Applicable Urban Design Priorities that Project Should Achieve

Cliff View
Dallas, Texas

Cliff View Apartments
 Dallas, Texas

CONCEPTUAL SITE PLAN

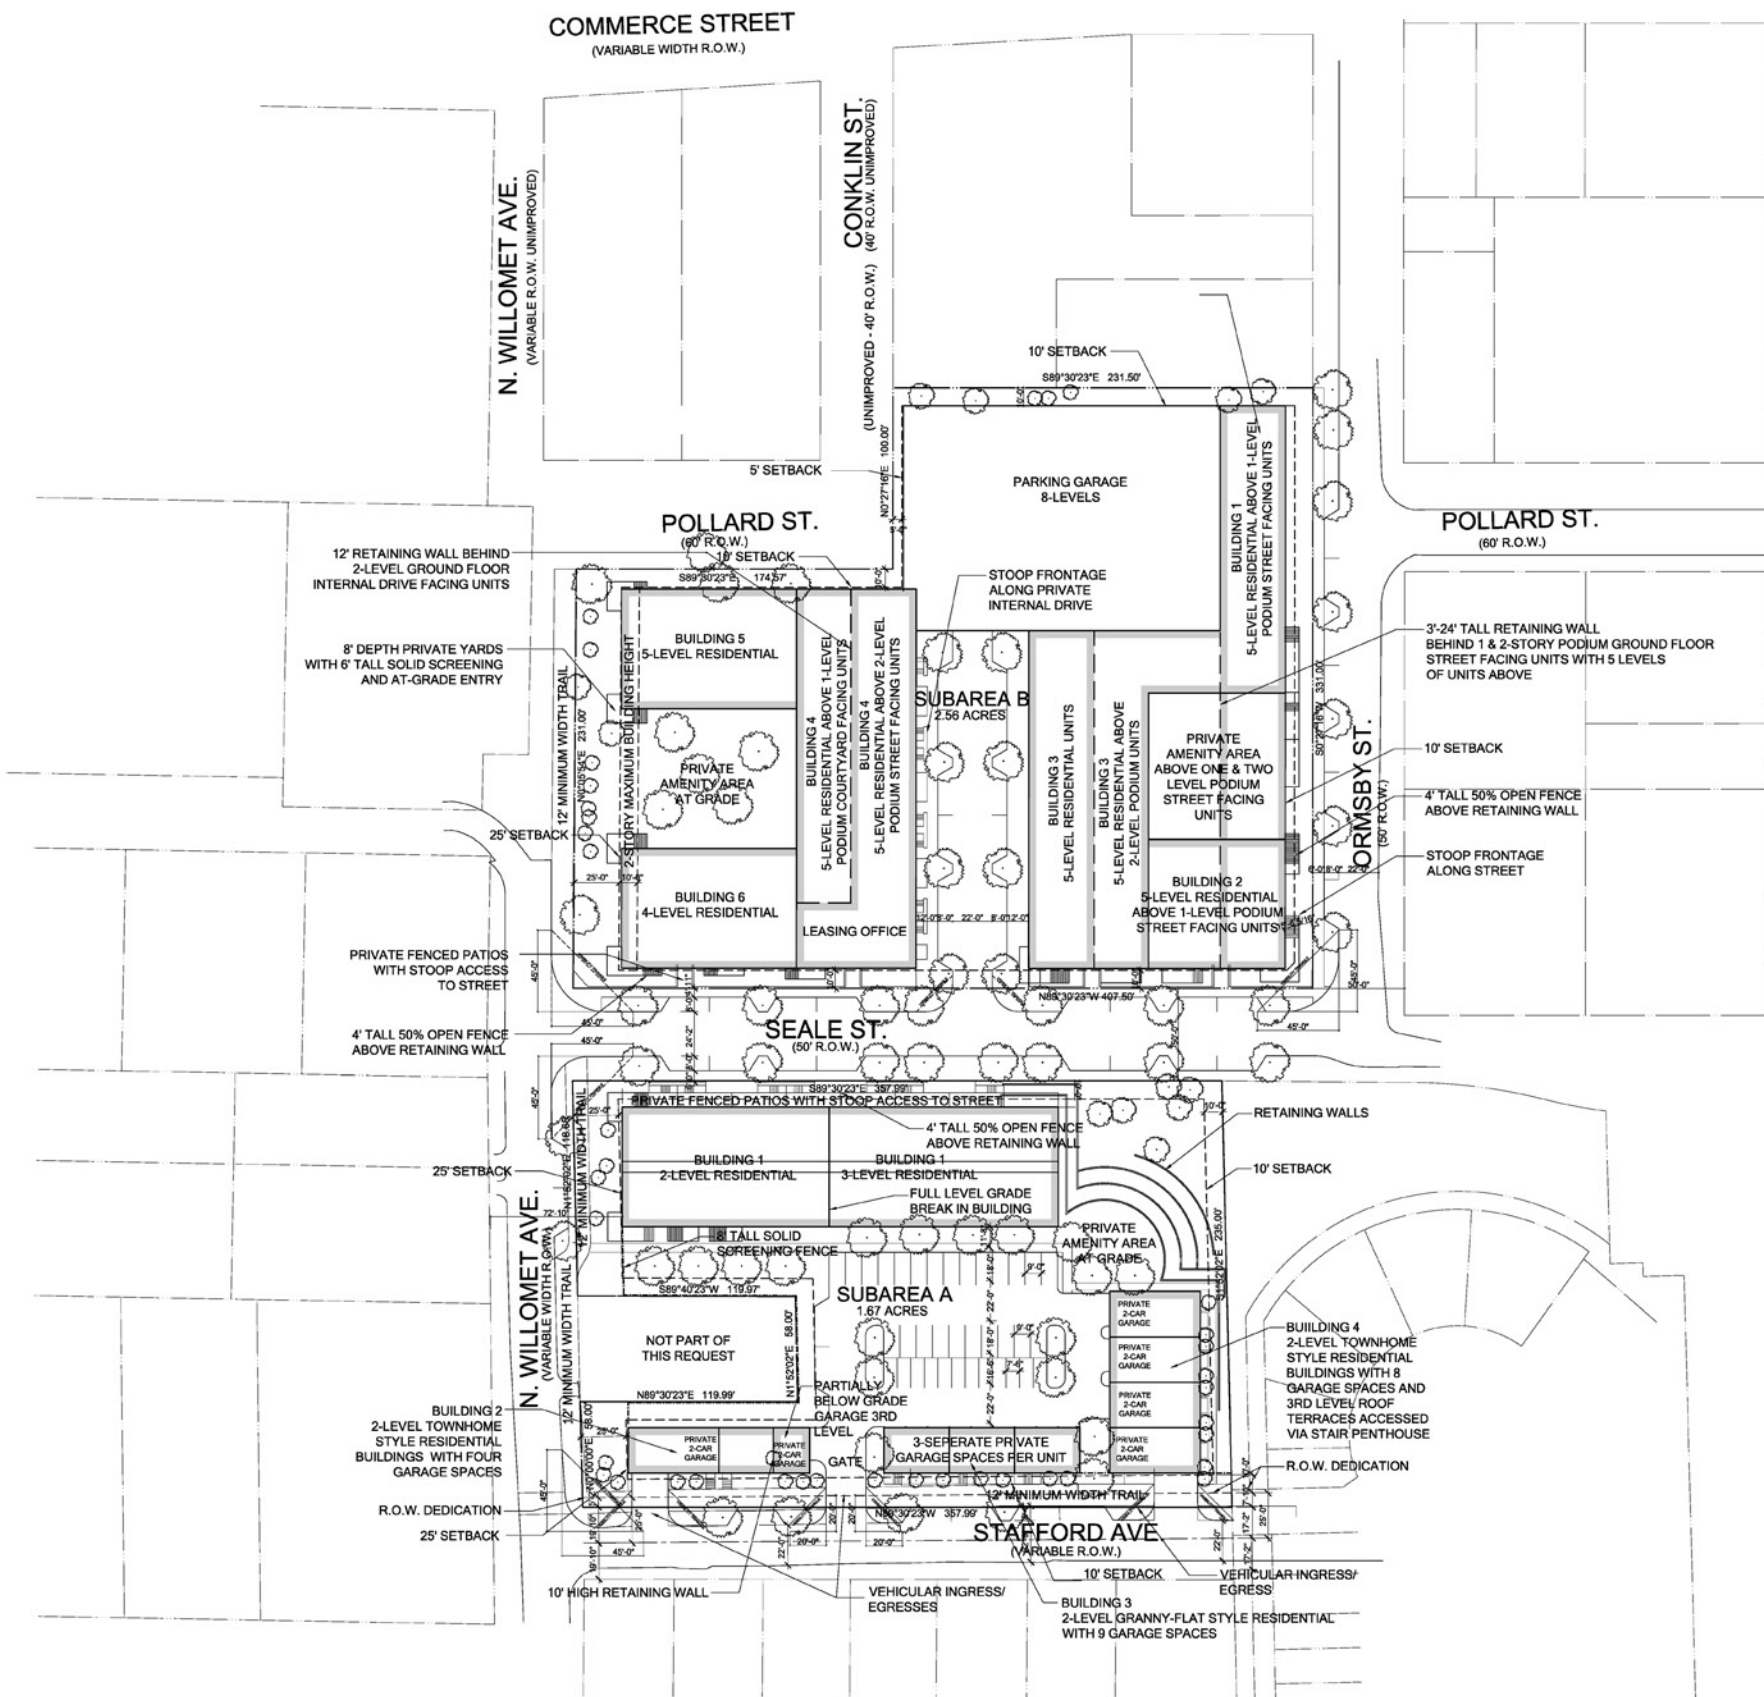
- [1] **Minimize width of private vehicular drives on Stafford and utilize high quality materials where garage entries are visible from the street -**
Where building orientation requires private garages visible from the public street, driveway widths should be minimized and high quality materials should be used to integrate the entries into the facade.

- [2] **Investigate opportunity to re-imagine retaining wall terraces at the south-east end of Seale Street as a more interactive landscape feature -**
By creating an occupiable transition from the lower level to the upper terraces through steps or other means, this area can be utilized as a place to congregate and would also provide greater connectivity through the site and to the proposed trail.

- [3] **Upper levels of structured garage, where visible from Commerce, should be visibly softened through the use of facade articulation or screening -**
Though the garage currently backs up to industrial uses, portions of the upper levels will be visible from Commerce due to its height. Effort should be made to integrate the garage into the building facade through screening or materiality where visible.

- [4] **Opportunities to employ integrated storm water management techniques should be investigated throughout the site landscape features -**
Opportunities should be engaged to utilize integrated storm water management techniques throughout the landscape in an effort manage excess water on site and control runoff. This can be accomplished through the use of depressed planting beds throughout streetscape, rain gardens, and other water managing landscape features.
